Technical Service Bulletin

10 Oil is lost from the filler cap

10 24 28 2059446/7 October 8, 2024. Supersedes Technical Service Bulletin Group 10 number 23-25 dated January 24, 2023 for reasons listed below.

Model(s)	Year	VIN Range	Vehicle-Specific Equipment
All Audi Models	2017 – 2020	All	With Supercharged or Turbocharged engine

Figure 1. Breather line for the Turbocharged V6.

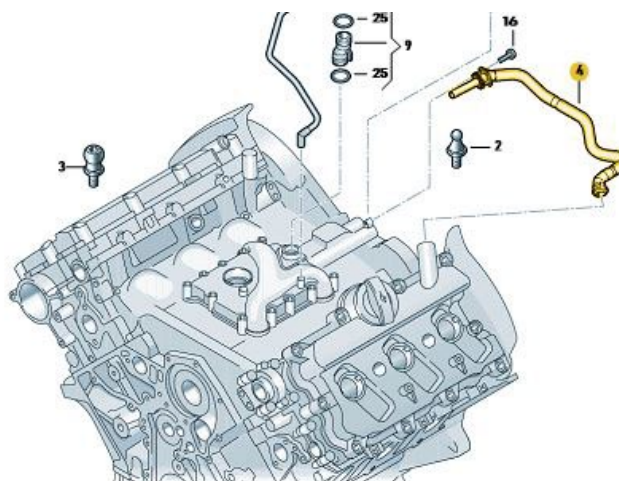
A faulty membrane in the breather line can result in excess pressure in the crankcase and therefore some oil is lost through the filler cap.

A breather line with an improved membrane has been implemented in production.

Replace the breather line (different variants available, only order by VIN) by following the Elsa repair manual (Figures 1 and 2).
